Memorandum

Response to Public Comments from February 5, 2019 Wausau Water Works Commission Meeting and February 27, 2019 Email from Jim Force

Donohue Construction Cost Opinions | Gerbitz-Led Projects
Large Wastewater Treatment Facility Projects

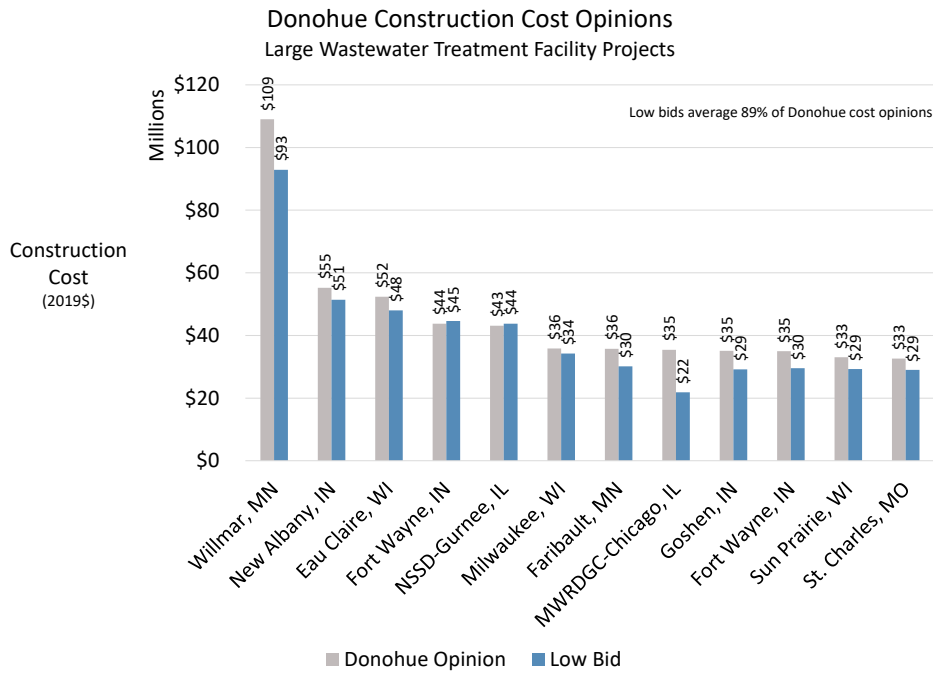
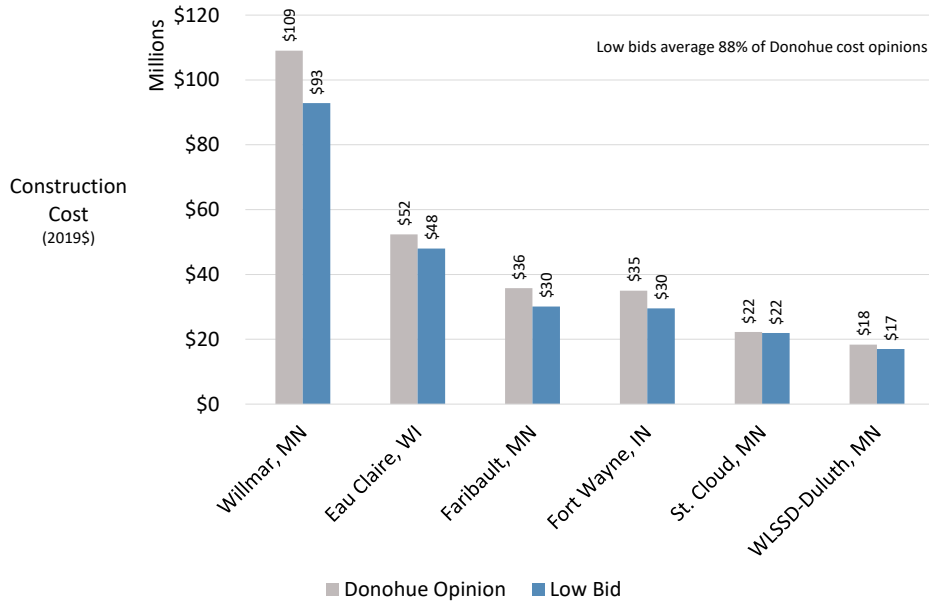
[Mr. Urbanek] feels the capital cost discussion is very brief. The exclusions aren't defined and the probability for completing the project for \$80 million is not defined. If this goes forward he suggests getting an \$80 million guarantee from Donohue. When you look at the estimate, 30% of the cost is for unidentified items. There could be errors, omissions, contingencies and training. Is it in the estimate or isn't it. He believes the operating and maintenance costs will also increase due to more equipment, more systems and more processes. His suggestion is to update the scope. It is important to have a meaningful and valid cost estimate.

This Statement includes multiple concerns. We attempt to address each below. First, however, reviewing Donohue's track record estimating the cost of large wastewater treatment facility improvement projects might alleviate the concerns of some. The figure below shows Donohue construction cost opinions and low bids for *all* Donohue projects that exceeded \$30M in construction.

The figure below shows Donohue construction cost opinions and low bids for large wastewater treatment facility projects led by Mike Gerbitz (Donohue Project Manager for the Wausau Project).

The previous figures reveal an exceptional track record of estimating construction costs and avoiding bid-day cost surprises. This is a reflection of our rigorous adherence to a design process that requires multiple, detailed construction cost opinions. Donohue produces five Design Phase construction cost opinions: the Preliminary Layout Design Phase (1), Final Layout Design Phase (1), and Final Design Phase (3). After the planning phase, construction cost opinions are produced in the same manner contractors use to generate their bids: using quantity take-offs from the drawings, major equipment quotes, and material quotes or costs from recent projects.
